REMARKS

DRAWING AMENDMENTS

Figure 1

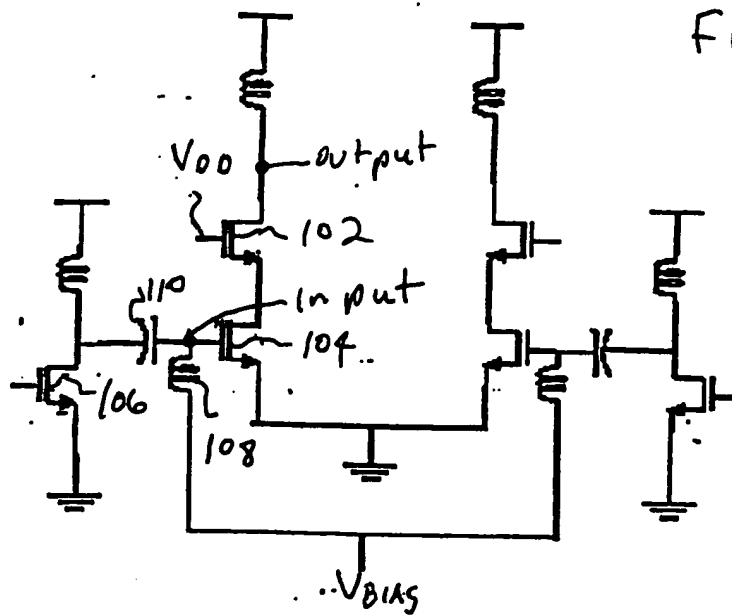
In the Office Action, the Examiner objected to the Drawings stating that Figure 1 should be labeled as "Prior Art" because only that which is old is shown. By the foregoing Amendment, Applicants have amended Figure 1 to accommodate the Examiner. Accordingly, Applicants respectfully request that the Examiner reconsider and remove the objection to the Drawings.

The attached sheet of drawings includes changes to Figure 1. This sheet, which includes Figures 1, 2, and 3, replaces the original sheet including Figures 1, 2, and 3. Figure 1 has been labeled "Prior Art."

PRIOR
ART
